DATE: February 28, 2022
PROJECT #: 2170
PROJECT: Casper College Gateway HVAC Redesign
OWNER: Casper College
Casper, Wyoming
BID DATE/TIME: March 3, 2022 / 2:00 PM MST
BID LOCATION: Casper College
Gateway Building, Room 311A
1910 Lisco Drive
Casper, Wyoming

End of Addendum #01

SECTION - 1 PARTIAL SHT. S3.00

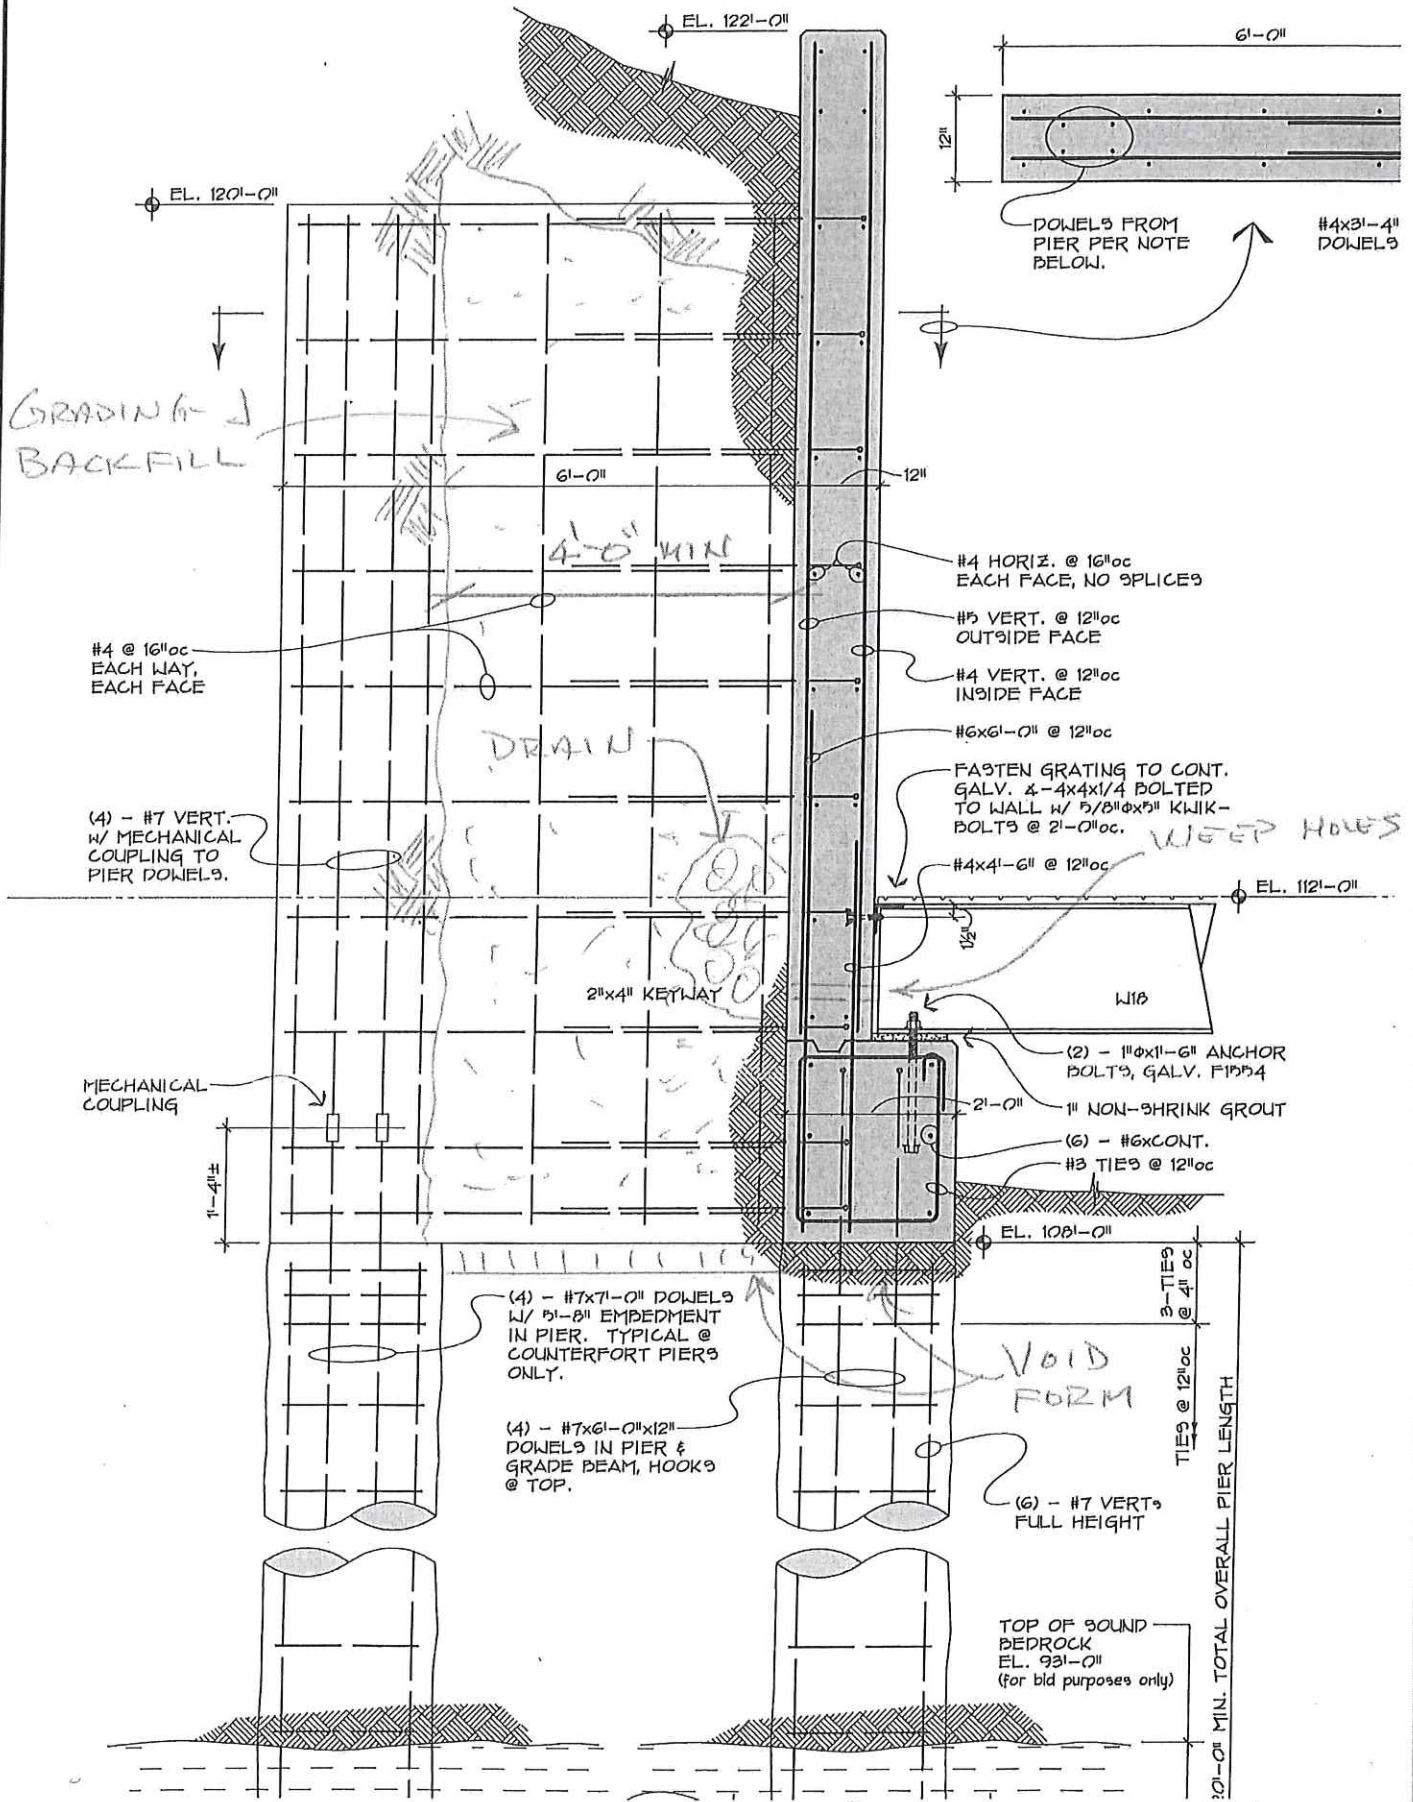
1. **Plan Sheet S3.0:** Section-1 and Section-2: Add wall backfill requirements as follows: Backfill walls with imported granular soils conforming to WYDOT Grading-J and add French drain at the walls with weep-holes as shown on the attached partial sheet S3.00. Add 4" void form under grade beams as shown on the attached partial sheet S3.00.
2. **Duct Support Plan Sheet S3.0 – Clarification:** It is important that the General Contractor and Mechanical Contractor coordinate with the Duct Manufacturer on the locations of the duct supports. The duct supports are located at existing columns and must be located as such. The supports are shown at the locations of the columns, but these locations must be field verified by the contractor(s). The duct manufacturer will be required to locate their joints so that they clear the duct supports.
